PL201900032  
PL2019-32

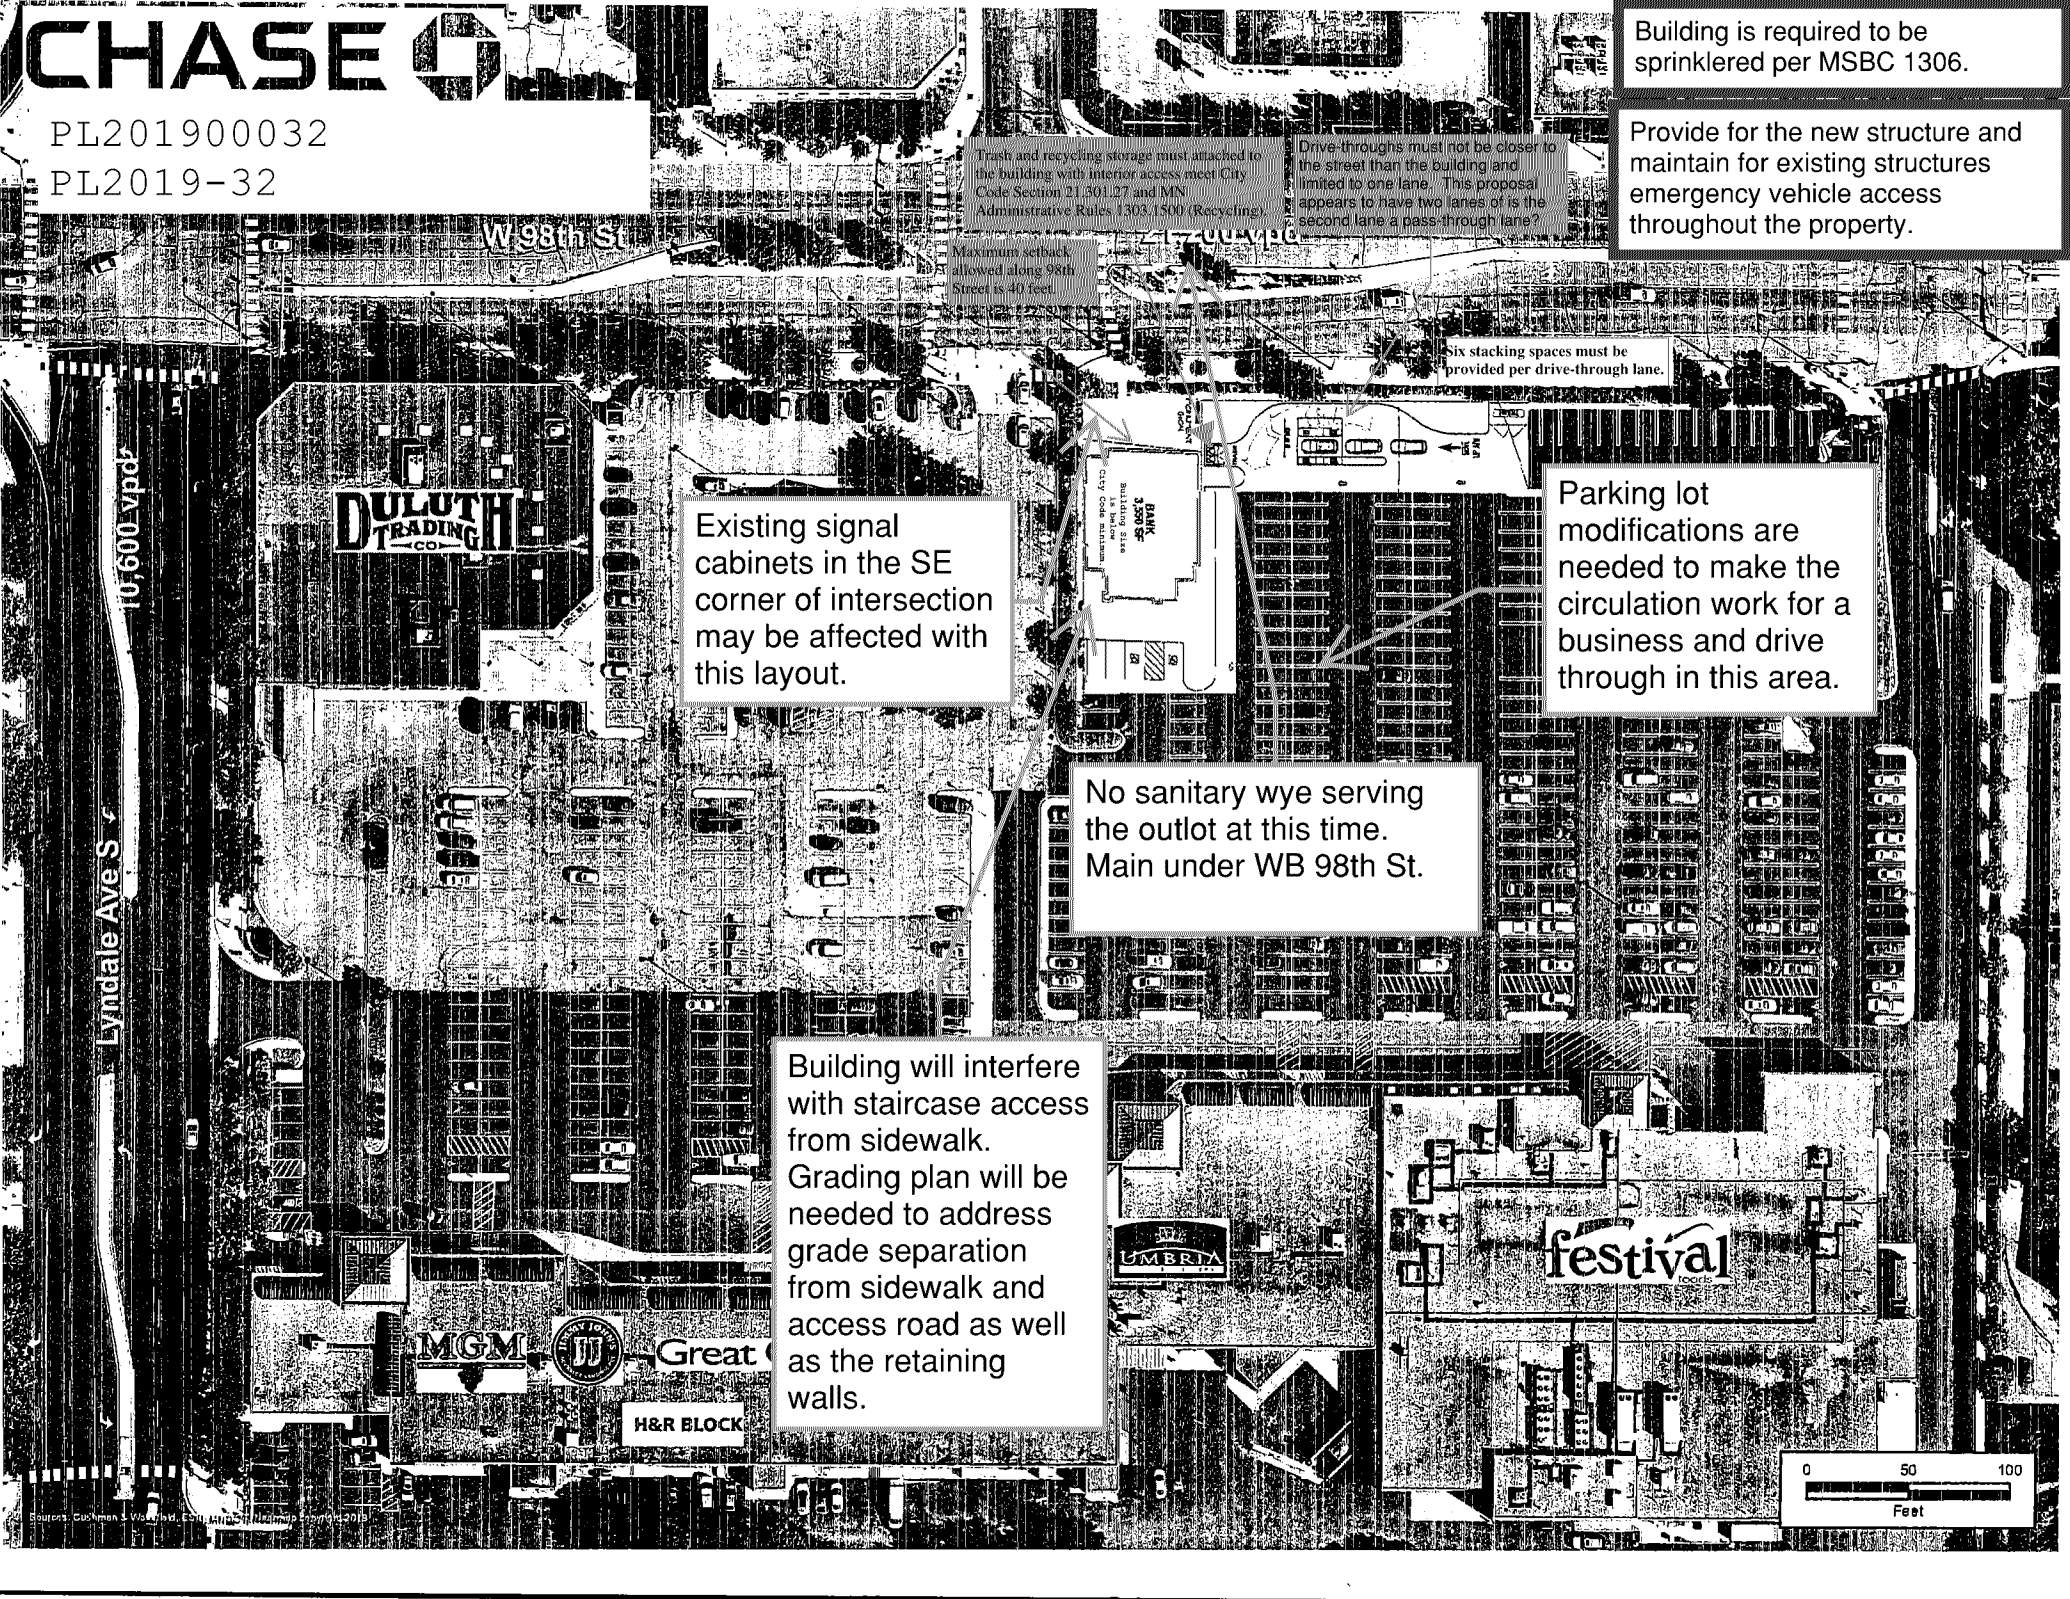
Building is required to be sprinklered per MSBC 1306.

Provide for the new structure and maintain for existing structures emergency vehicle access throughout the property.

Trash and recycling storage must be attached to the building with interior access, meet City Code Section 21.501.27 and MN Administrative Rules 1303.1500 (Recycling).

Drive-throughs must not be closer to the street than the building and limited to one lane. This proposal appears to have two lanes or is the second lane a pass-through lane?

Maximum setback allowed along 98th Street is 40 feet.

Six stacking spaces must be provided per drive-through lane.

Existing signal cabinets in the SE corner of intersection may be affected with this layout.

Parking lot modifications are needed to make the circulation work for a business and drive through in this area.

No sanitary wye serving the outlet at this time. Main under WB 98th St.

Building will interfere with staircase access from sidewalk. Grading plan will be needed to address grade separation from sidewalk and access road as well as the retaining walls.
